# ADDENDUM NO. 2

**August 3, 2026**

## **MERRILLVILLE HS CULINARY AND MEETING AREA RENOVATIONS AND MERRILLVILLE CSC CENTRAL OFFICE ADDITION AND RENOVATION PROJECT**

**Addendum Two (AD.02)** to the drawings and specifications prepared by Gibraltar Design for **Merrillville HS Culinary and Meeting Area Renovations and Merrillville CSC Central Office Addition and Renovation** for Merrillville Community School Corporation, Merrillville, Indiana.

**FIRST FLOOR REFLECTED CEILING PLAN**

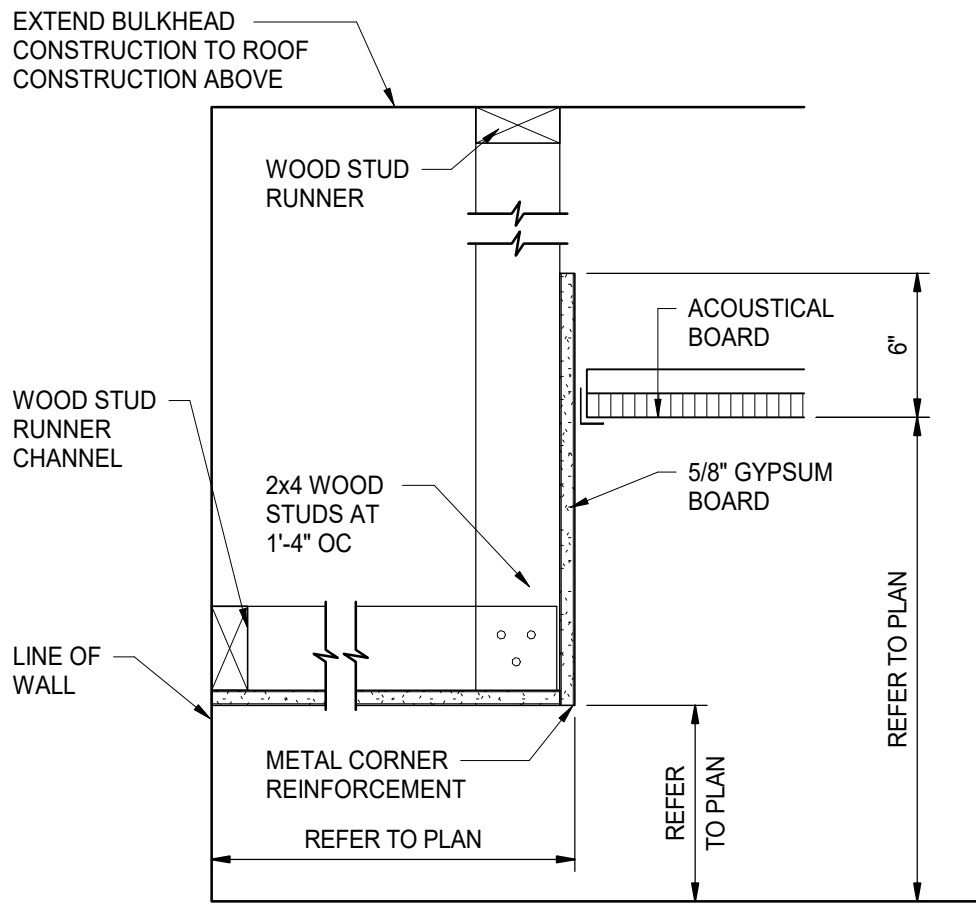
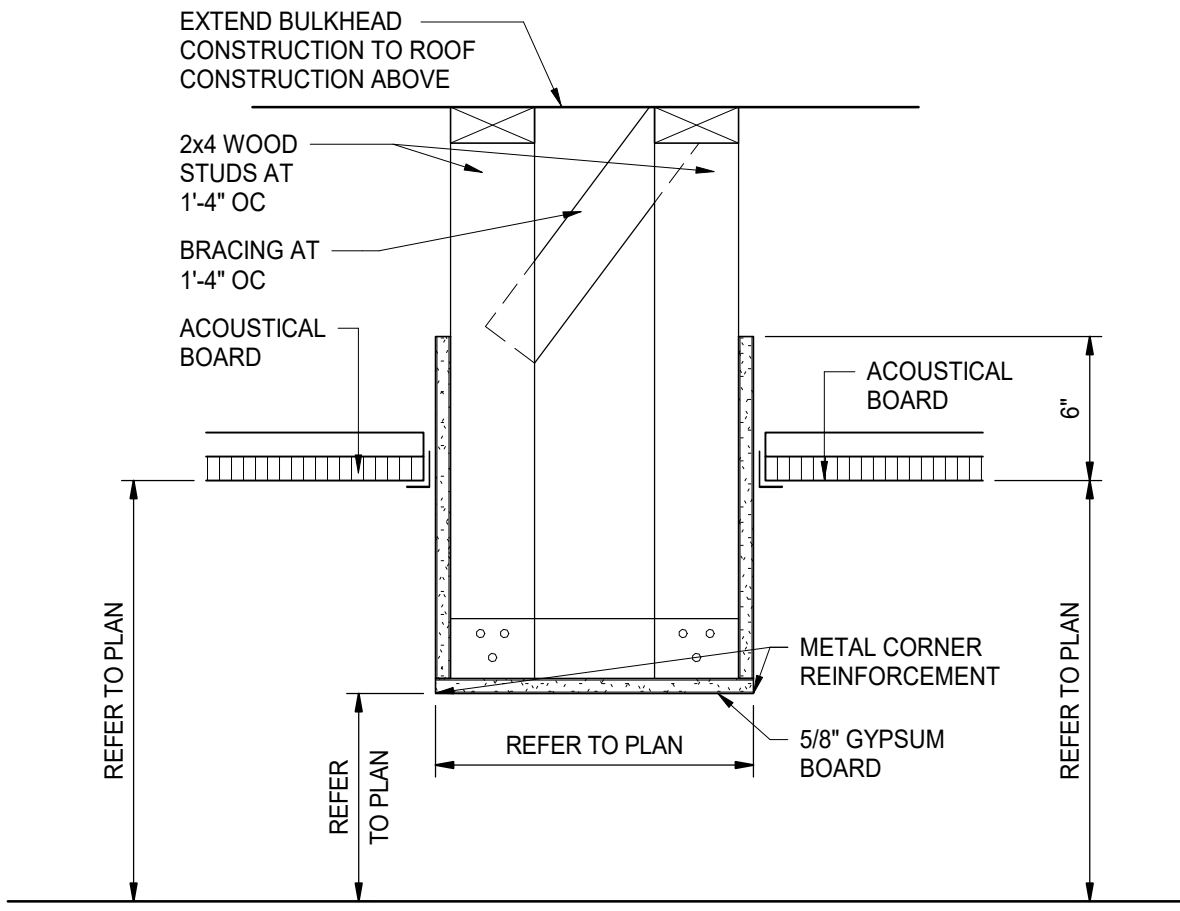
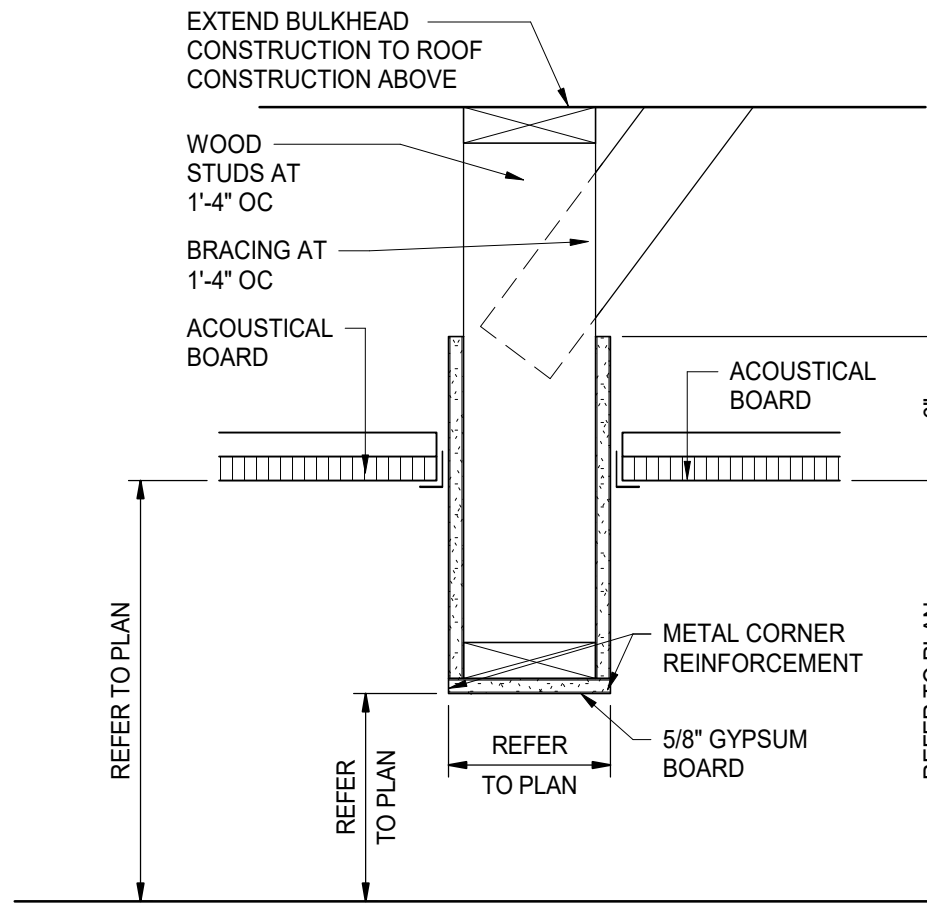
1. Revised extent of new ceiling in General Office A-126.
